Current Zoning: R-3 (single family residential)
Proposed Zoning: R-8MF(CD) (multi-family residential, conditional)
with five-year vested rights

Approximately 38.4 acres located on the east side of Shopton Road
West north of South Tryon Street.
(Outside City Limits)

The petition proposes to allow a for-sale townhouse community located in Southwest Charlotte, across from the McDowell Nature Preserve.

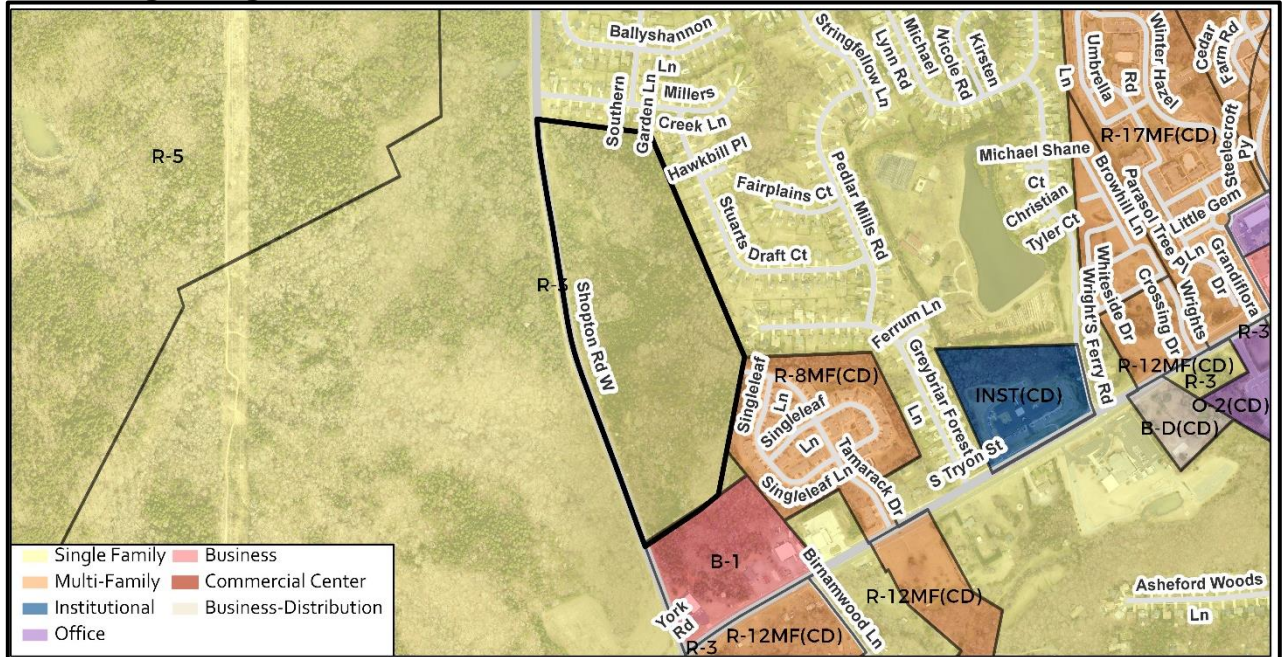
- Three points of ingress/egress onto Shopton Road West.
- Creates an internal network of public and private streets and alleyways.
- ~~Proposed left turn lanes on Shopton Road West at each proposed access point to the site.~~

- **Installs a 2nd southbound right turn lane along Shopton Road West at South Tryon Street (to create dual right turn lanes).** Petitioner agrees to install pavement widening, pedestrian refuge island, sidewalk and ramps, and associated pavement markings for addition of right turn lane only.

- **Developer shall provide for traffic signal relocation and/or replacement of existing traffic signal mast arms, including relocation of associated traffic signal controls and signage as required for the Petitioner-installed right turn lane at the intersection of Shopton Road West and South Tryon Street.**

- **Petitioner will install a right-in/right-out connection with a four (4) foot wide center concrete median island along Shopton Road West at the proposed Site access and a northbound right turn lane with 50 feet of storage at proposed Site Access #1.**

- **Petitioner will install a southbound left turn lane with 150 feet of storage along Shopton Road West for a full movement connection and a northbound right turn lane with 50 feet of storage at proposed Site Access #2;**

- **Petitioner will install a right-in/right-out connection with 4-foot wide center concrete median island along Shopton Road West at the Site access and a northbound right turn lane with 75 feet of storage at proposed Site Access #3;**

- **Petitioner will widen Shopton Road West only as required for the road improvements indicated for Site Accesses #1, #2, and #3; and**
- **Illustrates future right-of-way dedication along Shopton Road West 57 feet from existing centerline.**

- **Proposes to provide a barrier or otherwise delay the connection of the proposed network required connection to existing Tamarack Drive until such time that the proposed street is turned over to CDOT, to ensure that construction traffic does not enter the site through existing Tamarack Drive.**
